SEAS DEADLINE 6 RESPONSE to APPLICANTS's SUBMISSIONS
SINCE DEADLINE 5, ISH3, Action Points and ExQ3
LANDSCAPE & VISUAL and CULTURAL HERITAGE

PINS Ref: EN020026
DEADLINE 6: APRIL 13, 2026

EN020026 SEA LINK DCO – DL6: RESPONSE BY NICHOLAS BRIDGES

ZTV ANALYSIS – IP ref FA62B0DA

Figure 14. Sea Link EN020026-000343-6.4.2.1 ES Figures Suffolk Landscape and Visual Part 7 of 7, page 7
 CUMULATIVE SCHEMES (MAJOR PROJECTS) SCREENED ZONE OF THEORETICAL VISIBILITY - EAST ANGLIA ONE NORTH AND EAST ANGLIA TWO OFFSHORE WIND FARMS

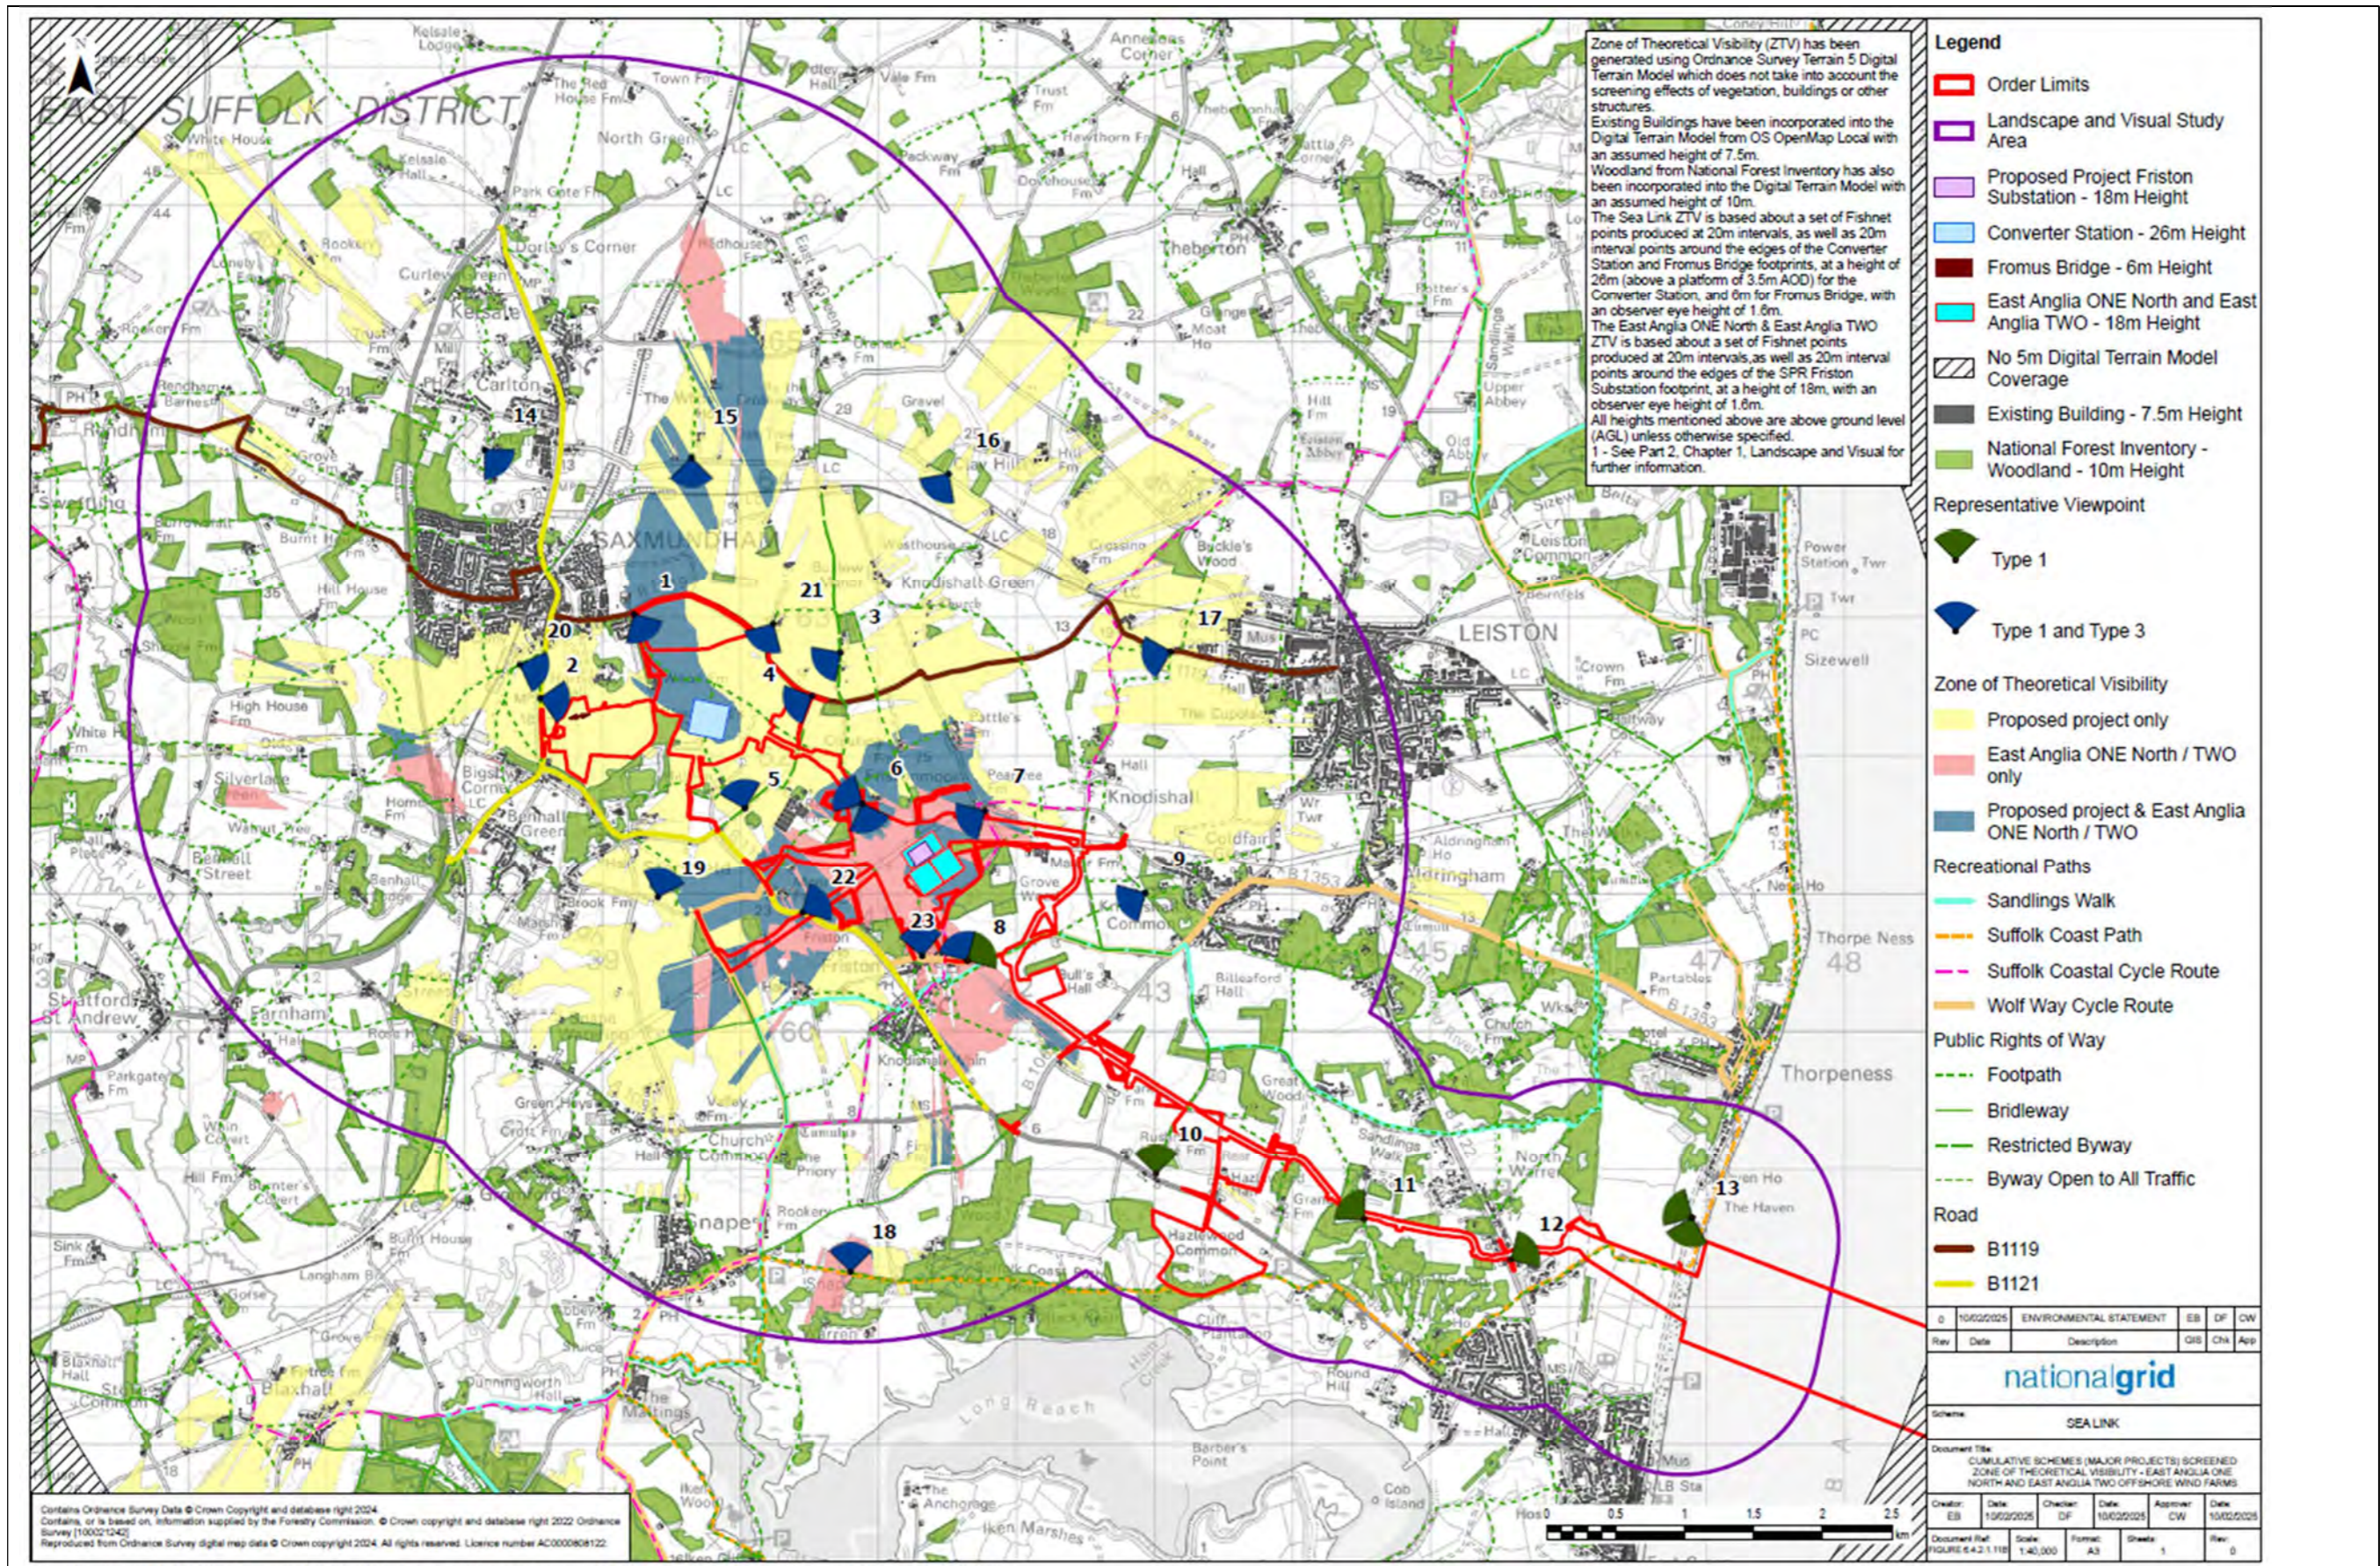
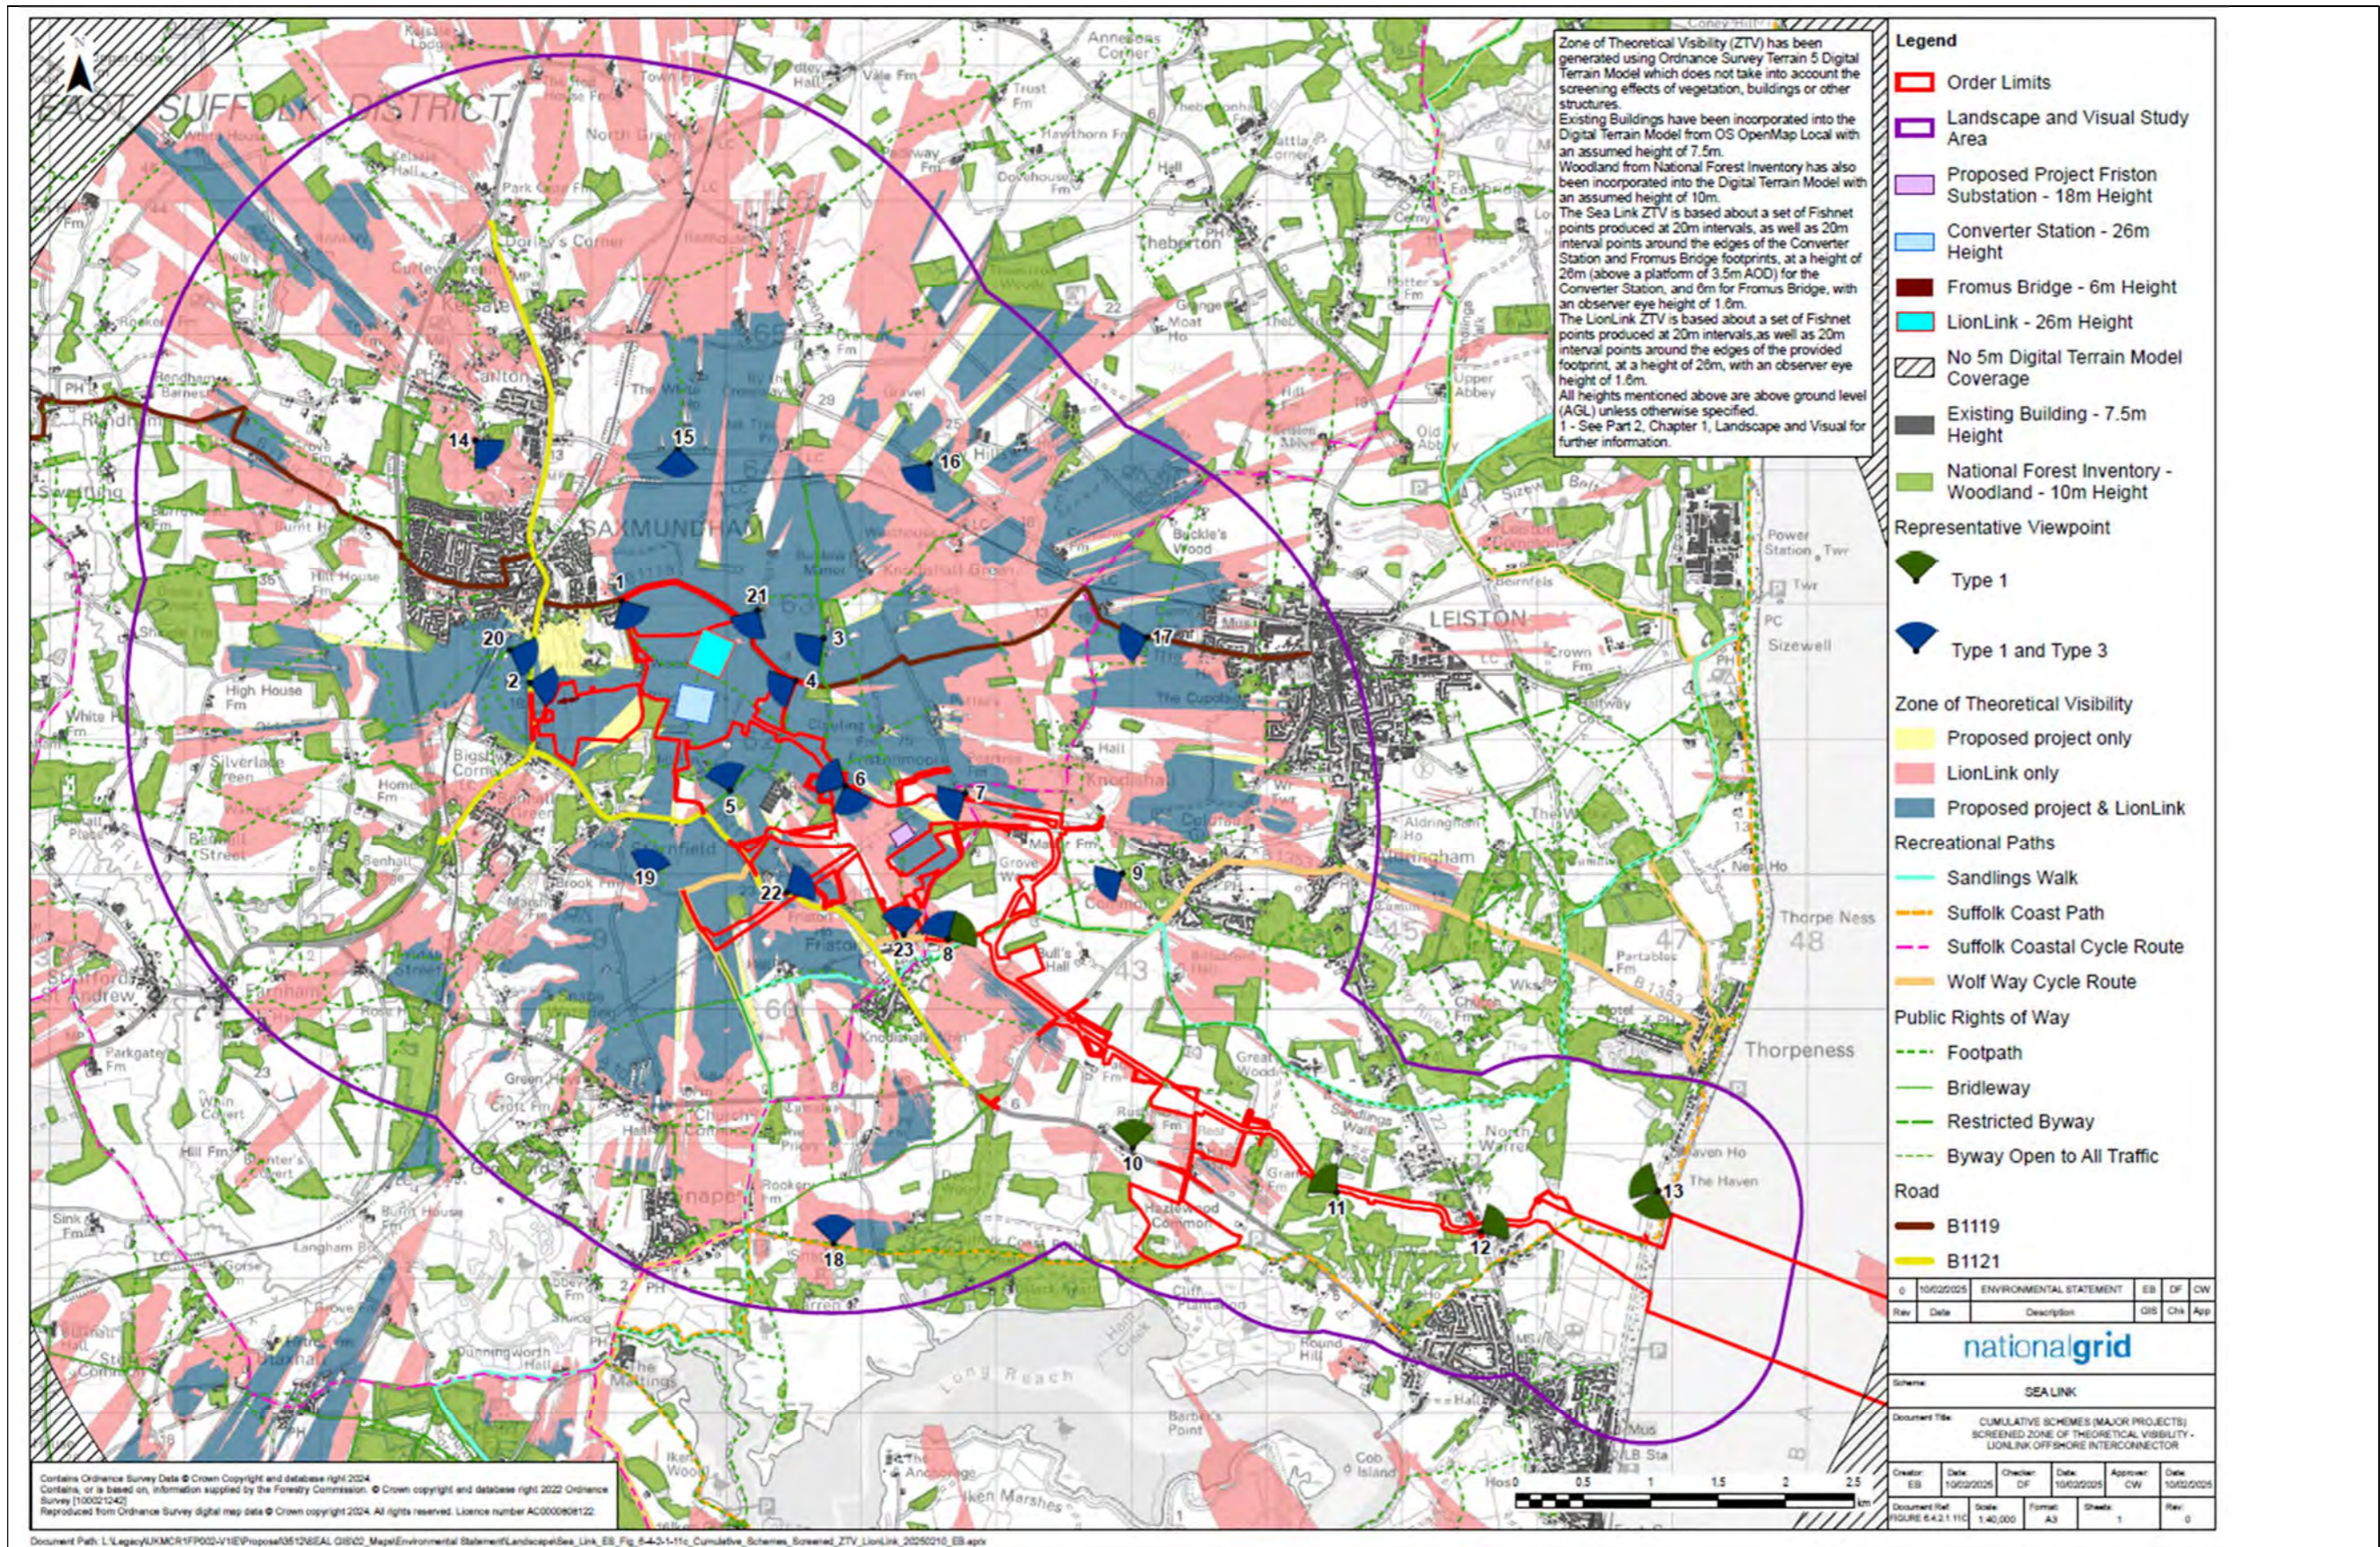
2.10. The 'shadow' patterns illustrate the 'shading' effects of woodland and buildings. The ZTV plans of the same proposed volumetric parameters (**Figures 12 to 17** below) show far less visibility than its PEIR ZTV plans. The accompanying textual details of the model's constraints are exactly the same (see the schedule below).

2.11. The **first question** is: why are the PEIR and DCO plans so completely different? Were the heights in the model changed? Were the shadowing criteria altered? Which is correct? If the DCO is correct, were the EA1N and EA2 ZTVs incorrect? These are simple technical points which can be explained easily.

- 3.1. The submitted DCO ZTV plans should be reviewed for their accuracy.
- 3.2. If they are correct, the applicant must explain why the PEIR was so different
